Access Compliance Report

Public Rights-of-Way

(Curb Ramps)

Intersection ID: 6454	Main Street: BRYAN_FURR_DR	Cross Street: SLATER_SPRINGS_DR	Location: NE
ADA ID: 066019F51185	Ramp Type: BlendTrans1	Initial Pass/Fail: Fail	Overall Compliance: No
Severity Score: 21.25			
Codes/Mitigation Info/Possible Solution		Field Measurements/Component Compliance

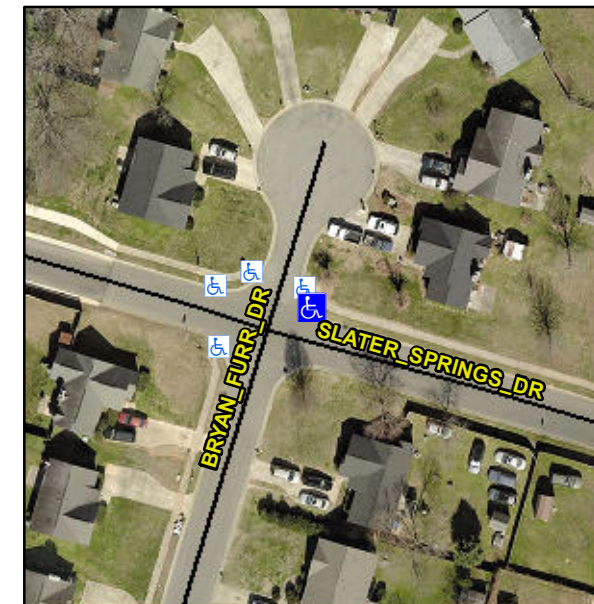
Not Found, R304.5.1, R304.5.3

Compliance	Description	Data	Compliance	Description	Data
N/A	Ramp Length (in)	54.0	Yes	BlendTrans Slope (%)	2.6
No	Ramp Width (in)	42.0	No	BlendTrans XSlope (%)	5.9
N/A	Flare Type LT	N/A	N/A	Flare Type RT	N/A
N/A	Flare Slope LT (%)	N/A	N/A	Flare Slope RT (%)	N/A
N/A	Flare Traversable LT?	N/A	N/A	Flare Traversable RT?	N/A
N/A	Landing Length (in)	N/A	N/A	DWS Provided?	N/A
N/A	Landing Width (in)	N/A	N/A	DWS Contrast?	N/A
N/A	Landing Slope (%)	N/A	N/A	DWS Length (in)	N/A
N/A	Landing X Slope (%)	N/A	N/A	DWS Full Width?	N/A
N/A	Landing Curb? (Y/N)	N/A	N/A	DWS Offset (in)	N/A
N/A	Shared Landing?	N/A			
N/A	Gutter Ponding?	N/A	N/A	Gutter Slope (%)	N/A
N/A	Gutter Lip Ht (in)	N/A	N/A	Gutter X Slope (%)	N/A
N/A	Painted X Walk1?	No	N/A	Painted X Walk2?	N/A
	X Walk 1 Direction	To S		X Walk 2 Direction	N/A
	X Walk 1 Width (in)	N/A		X Walk 2 Width (in)	N/A
	X Walk 1 Slope (%)	1.9		X Walk 2 Slope (%)	N/A
	X Walk 1 X Slope (%)	5.9		X Walk 2 X Slope (%)	N/A

N/A	Ramp inside XWalk1?	N/A	N/A	Ramp inside XWalk2?	N/A
	Road Slope (%)	5.9		Clear Space?	N/A
	Road X Slope (%)	1.9	N/A	Clear Space to XWalk (in)	N/A
N/A	Any Obstructions?	N/A	N/A	Storm Grate/Utility Hazard?	N/A
	Obstruction Type			Storm Grate/Utility Type	
		N/A			N/A
			Yes	Surface Condition? (G/P)	Good
			No	Curb Slope (%)	13.0

Remove & Replace Curb Ramp With Two New Directional Ramps or Equivalent.
